MONTGOMERY COUNTY HISTORIC PRESERVATION COMMISSION
STAFF REPORT

Address:	7329 Baltimore Avenue, Takoma Park	Meeting Date:	1/21/2026
Resource:	Non-Contributing Resource Takoma Park Historic District	Report Date:	1/14/2026
Applicant:	KAB Holding, LLC (Eric Saul, Architect)	Public Notice:	1/7/2026
Review:	HAWP	Tax Credit:	n/a
Permit Number:	1121582 REVISION	Staff:	Dan Bruechert
Proposal:	Revision to Previously Approved HAWP for Fenestration Alteration

BROWN RESIDENCE ADDITION AND RENOVATION

Figure 4: Revised fenestration proposal.

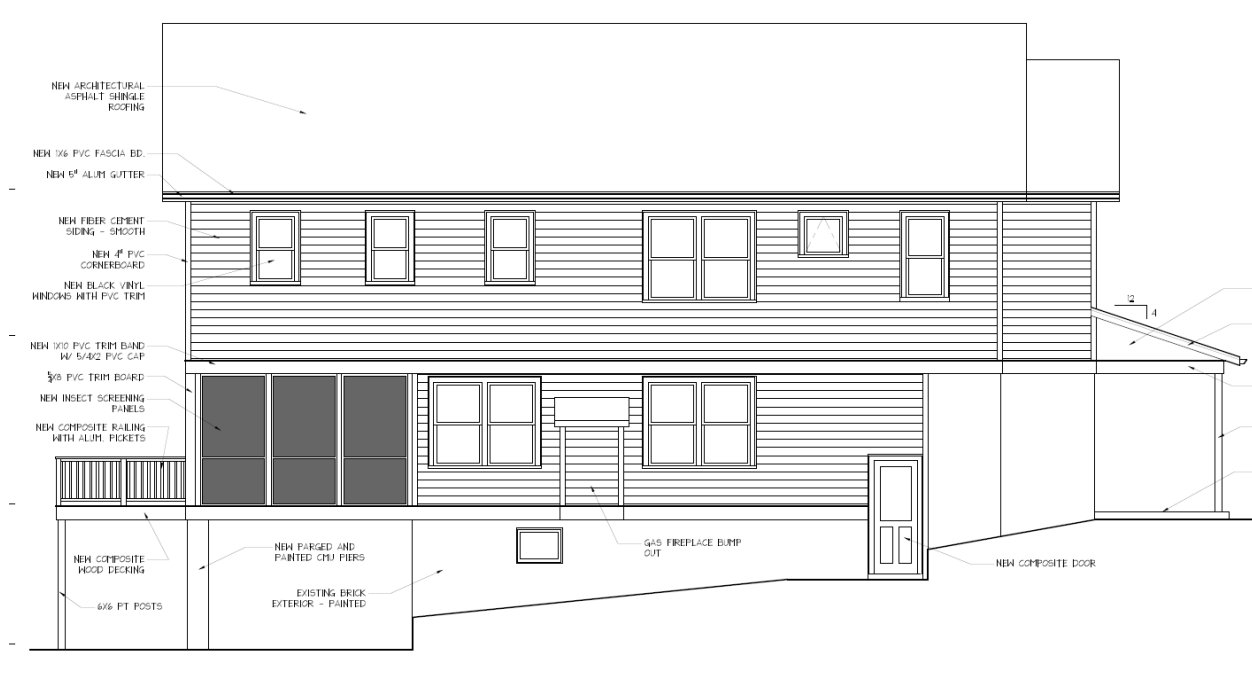
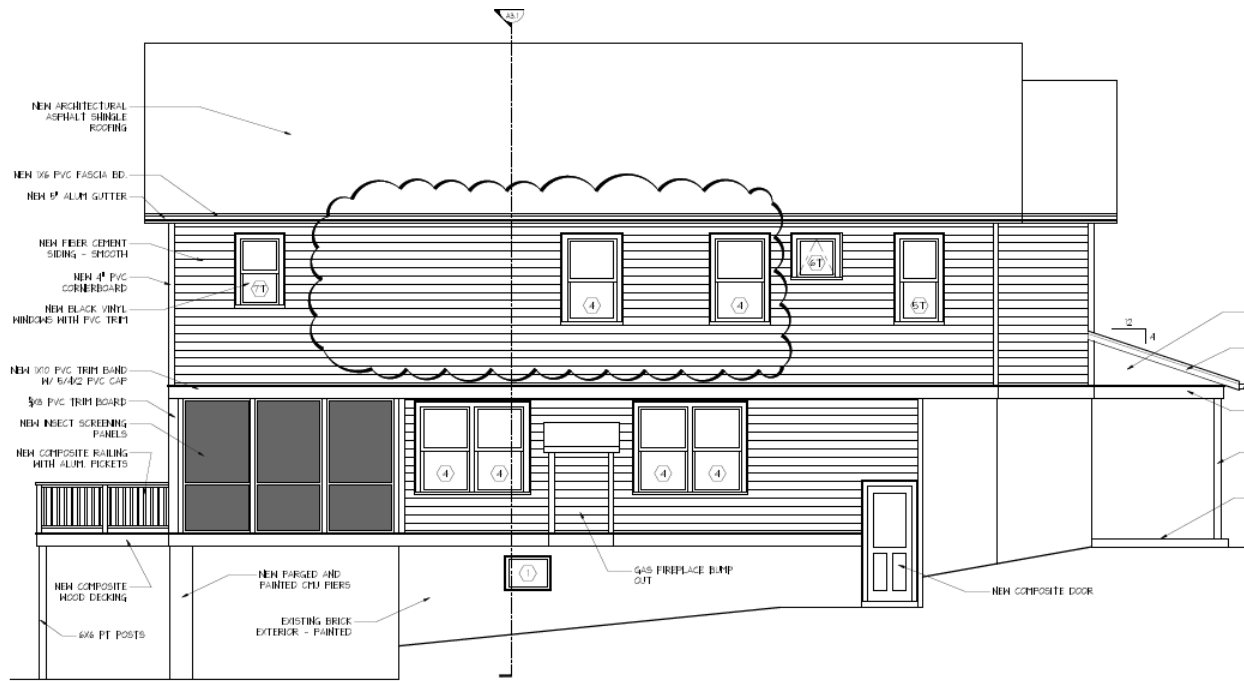
The approved HAWP changed the fenestration for all of the openings in the existing one-story Non-Contributing Resource. All of the second-floor fenestration was new and few of the second-floor windows were stacked above the first-floor openings (see Fig. 3, below). The revised fenestration (see Fig. 4, below, revisions bubbled) eliminates one window opening, changes a paired window opening to a single window, and enlarges and relocates one window. The windows specification are consistent with the windows approved at the August 2025 HAWP approval.

Staff finds the proposed change will not have a substantial impact on the character of the resource and, as the second story is a new feature, this change will not impact any existing materials. Additionally, Staff finds that the proposed revision will not change the size and mass of the approved HAWP, let alone to the degree the change would impair the character of the district as a whole, the standard required in the *Design Guidelines*. Staff recommends the HPC approve the HAWP revision under 24A-8(b)(2) and (d); the *Design Guidelines*; and *Standards #2* and *#9*.

Staff recommends that the Commission **approve** the HAWP application revision; under the Criteria for Issuance in Chapter 24A-8(2) and (d), having found that the proposal will not substantially alter the exterior features of the historic resource and is compatible in character with the district and the purposes of Chapter 24A;

2 PROPOSED SIDE (EAST) ELEVATION
 A2.1 1/4" = 1'-0"

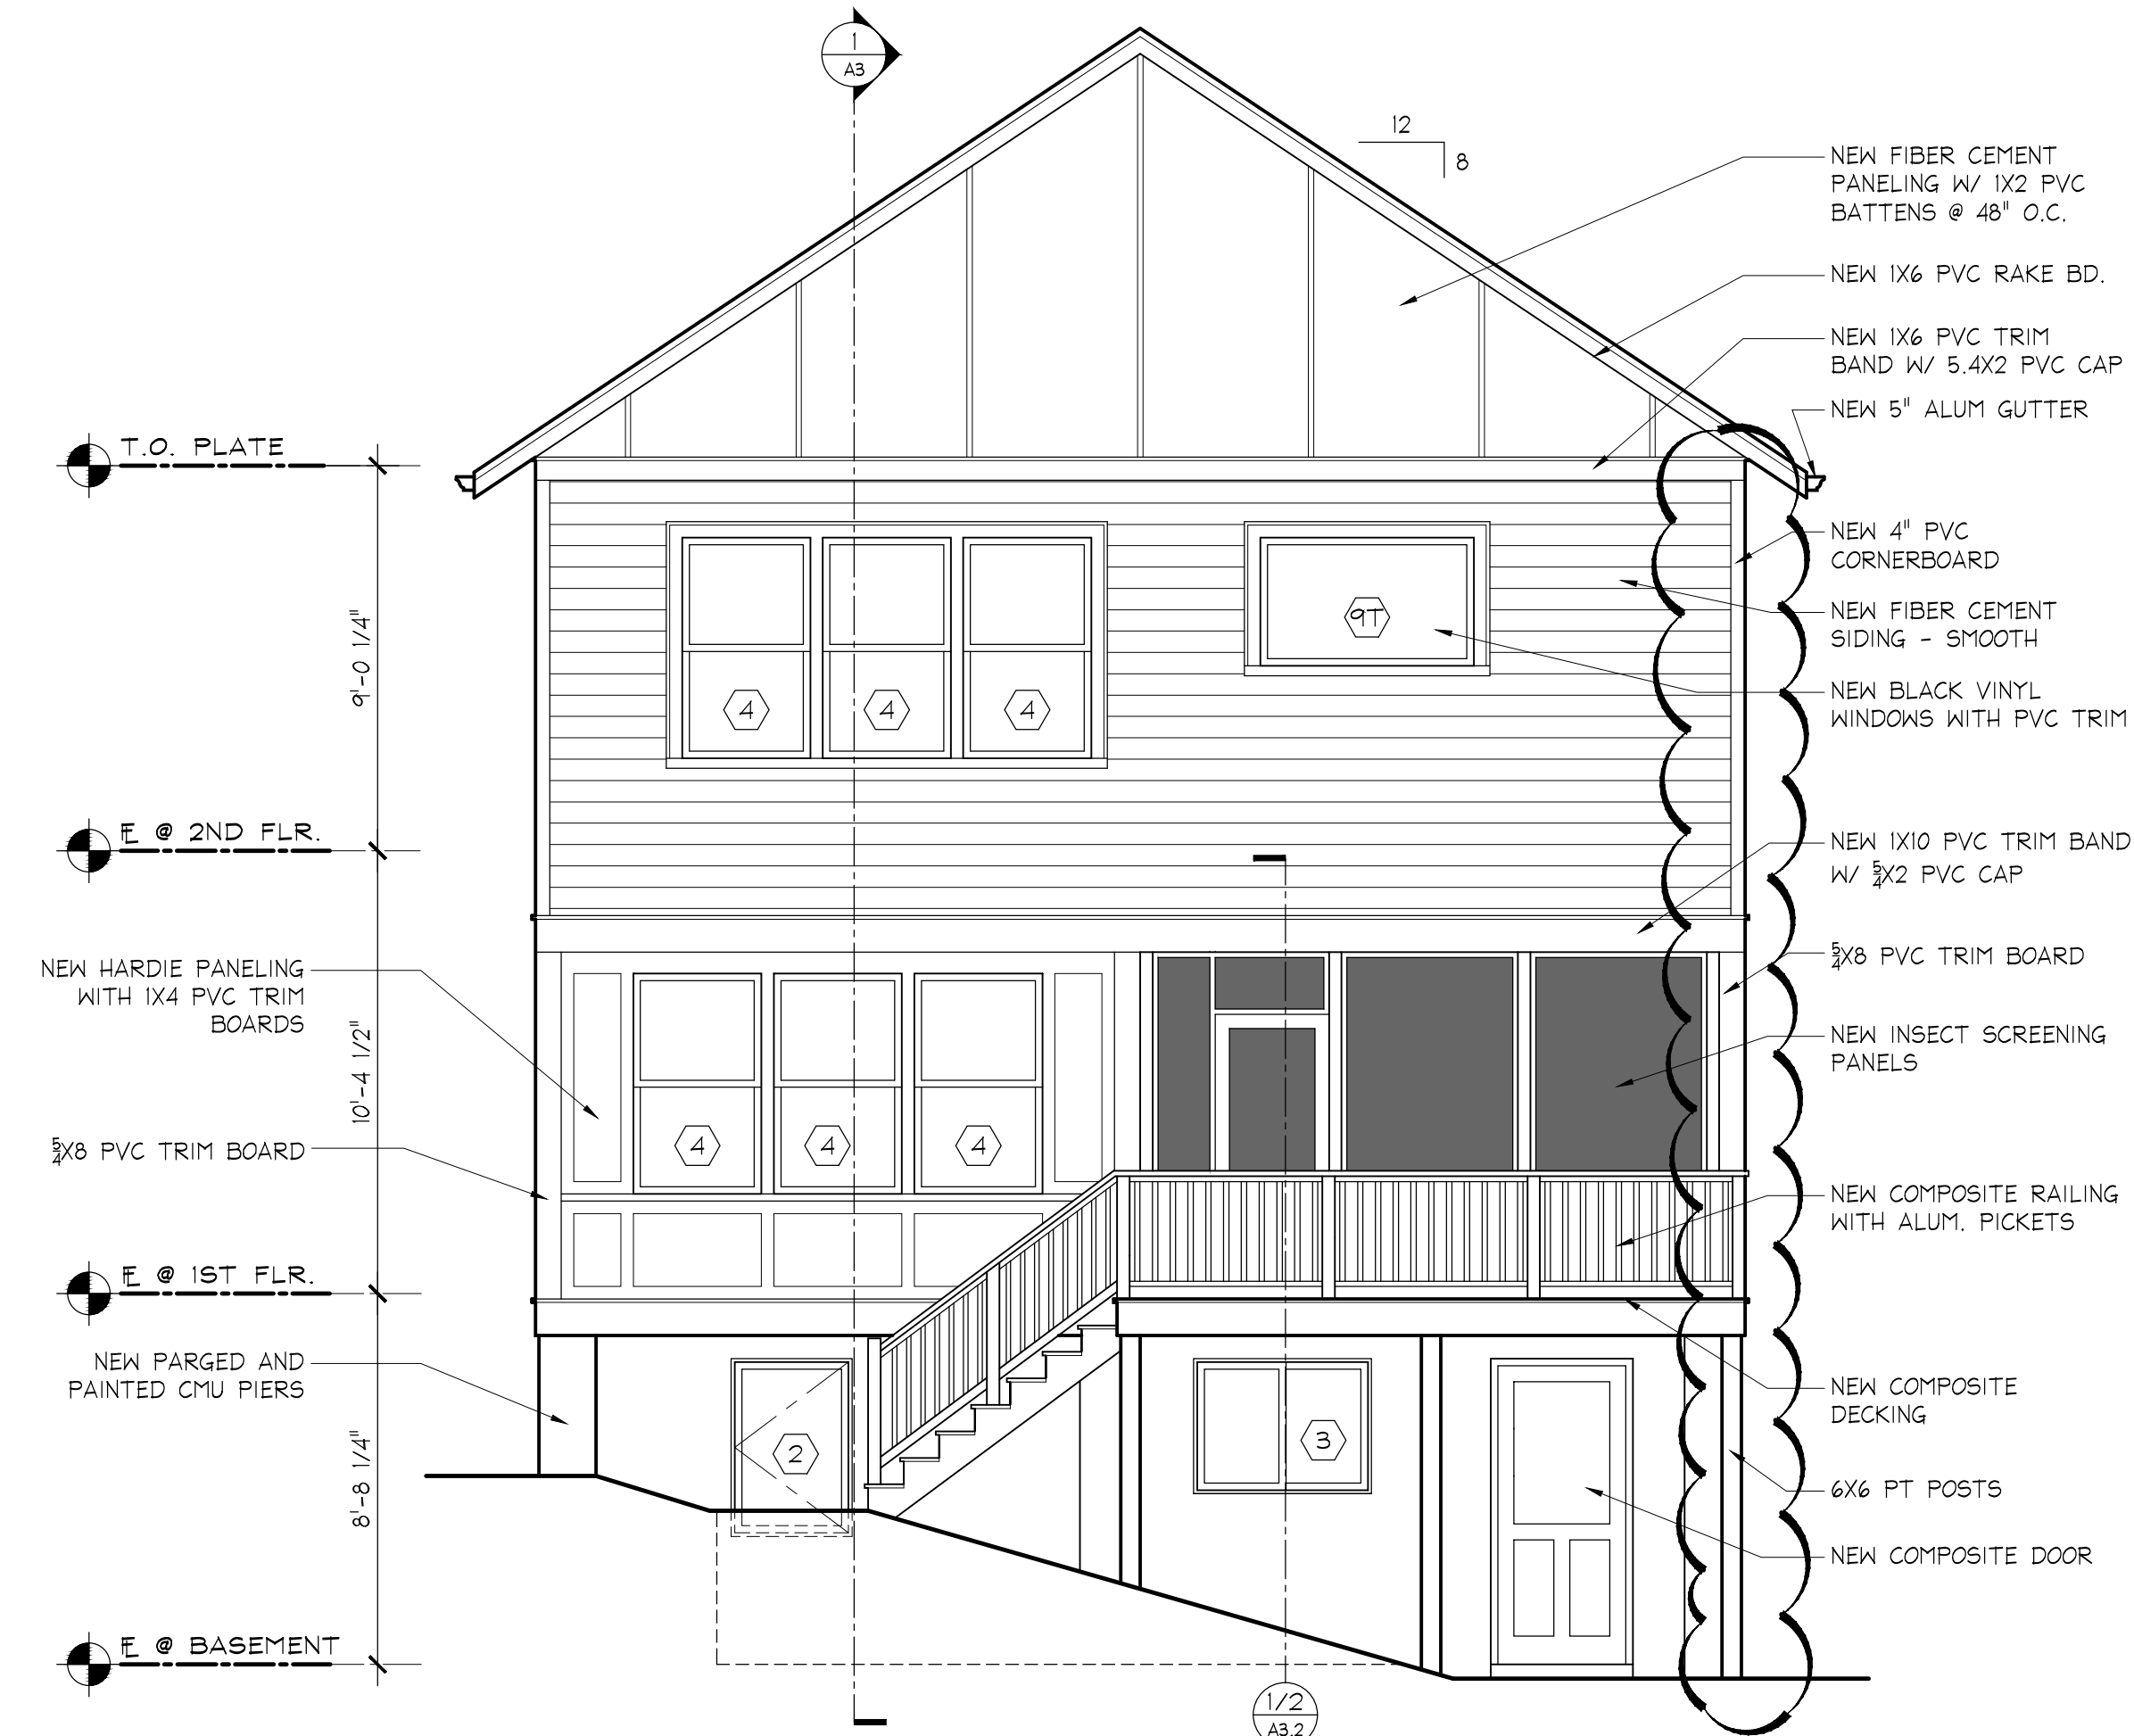
The applicant proposes to revise the approved fenestration on the east elevation of the approved design.
